PLANNING COMMISSION REPORT
Regular Agenda -Public Hearing Item

PC Staff Report
1/30/13

**ITEM NO. 9: **PRELIMINARY DEVELOPMENT PLAN FOR THE LINKS; 251 QUEENS
RD (MKM)****

PDP-12-00283: Consider a Preliminary Development Plan for The Links at Lawrence, a 630 unit multi-dwelling residential planned development with 9 hole golf course on approximately 81 acres located at 251 Queens Road and associated modification from the height limitation in the RM12 Base District. Submitted by Holloway Engineering, Surveying & Civil Design, PLLC., for Links at Lawrence, property owner of record.

Figure 2b. Proposed revised PDP, with building layout from previous PDP overlaid. Additional development area circled. The golf course has been pulled out of the sensitive areas also.

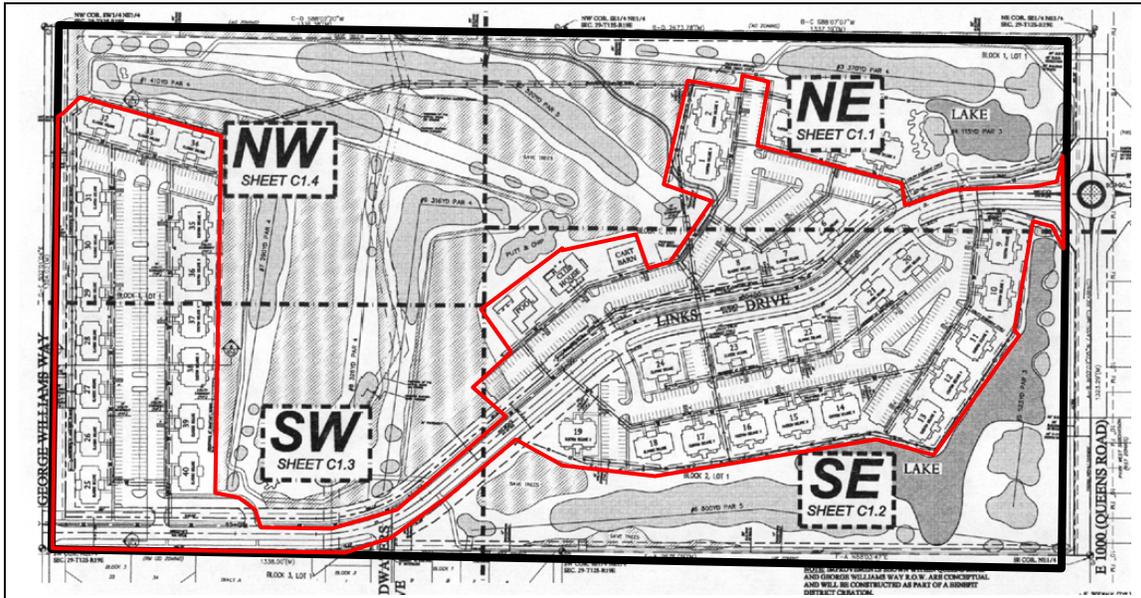
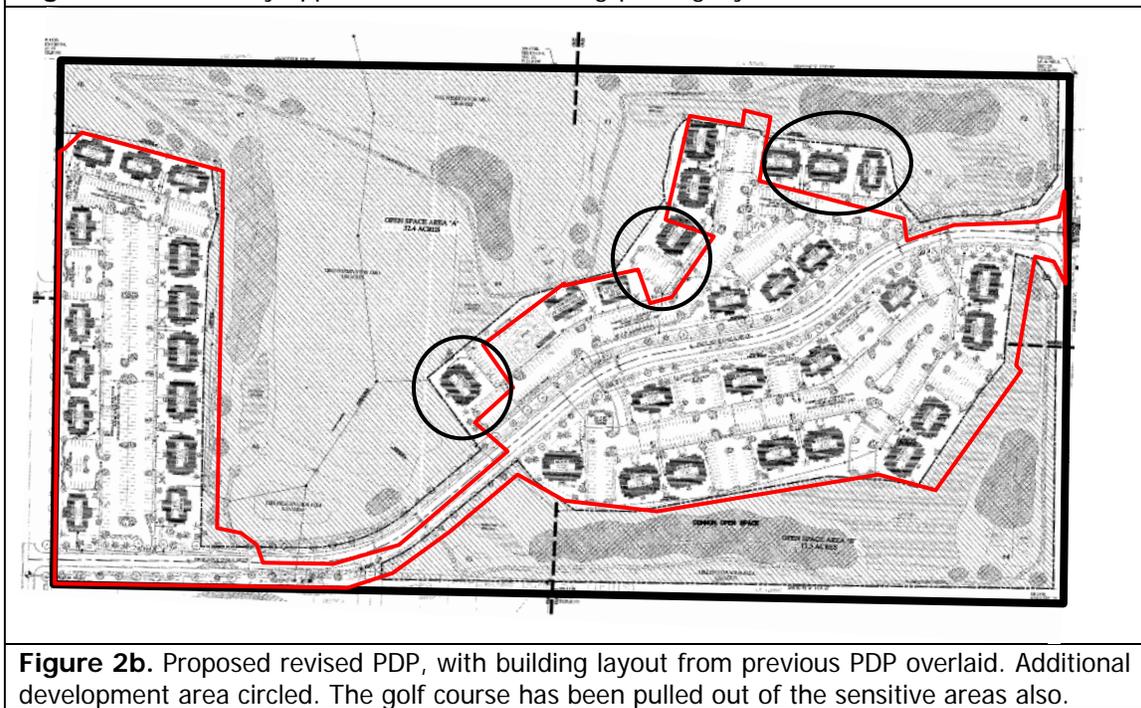
Figure 2 compares the development pattern in the previously approved PDP and that being proposed with the current PDP.

Figure 2a. Previously approved PDP with building/parking layout outlined in red.

Figure 3. Steep slopes (>15%) shown in red. The area being developed with buildings or pavement is outlined.

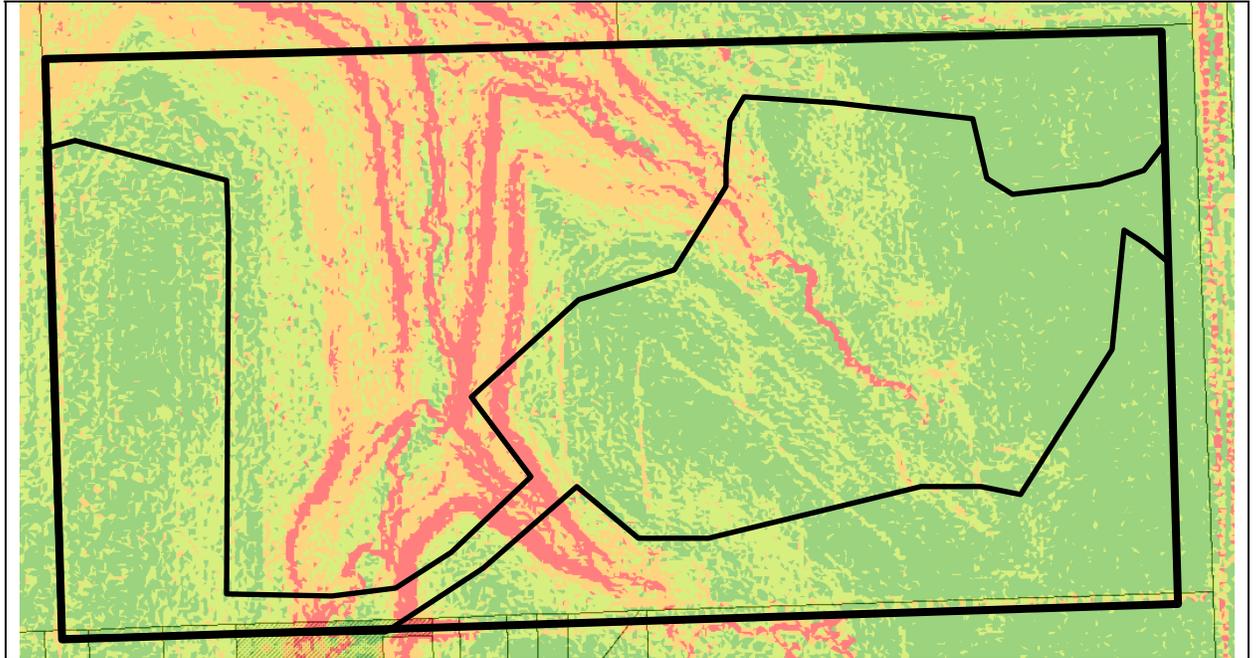
Steep slopes were included in the sensitive area site plan, although the Development Code does not require their protection as environmentally sensitive lands. The improvements being proposed to the site are located outside of this area with the exception of some of the golf course. (Figure 3)

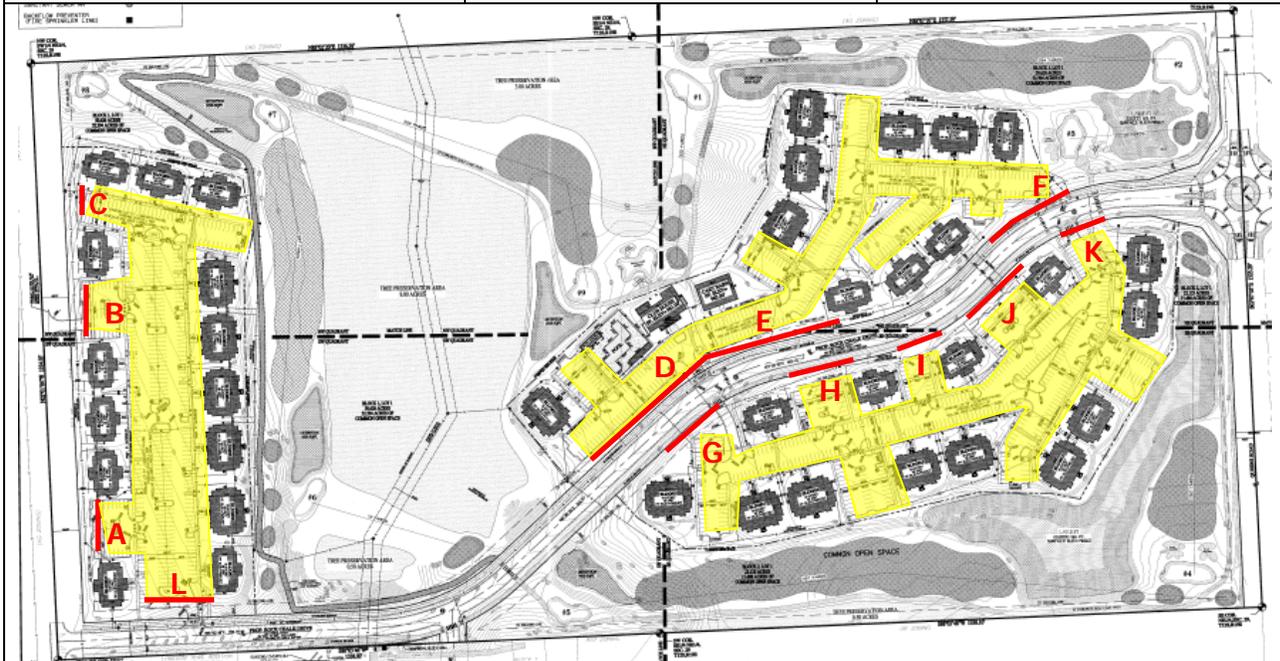
The proposed development, as conditioned, meets the standards for a Planned Development in Section 20-701, with approval of the modification being requested. The proposed development meets the minimum area requirement for a PD district. The applicant is requesting that the City Commission approve the requested modification to the height standard to allow the residential structures that are not fronting George Williams Way to be constructed 39 ft in height and the club house to be constructed 41.5 feet in height rather than the 35 feet that is permitted within the RM12 District. The club house is to be located in the interior of the site and is at least 640 feet from the nearest residentially zoned district. The residential buildings will be set back from the property line as noted in the following figure. The additional height proposed for the buildings (39 ft) is approximately 11% greater than that permitted by Code (35 ft). The requested modification should not negatively impact any nearby development or property owners.

Figure 5. The buildings which are included in the modification request for an increase in height are marked with red dots. The figures show the distance the building is setback from the property line (any additional row is noted in parenthesis). Minimum setback from adjacent property line is 130 ft in southwest corner.
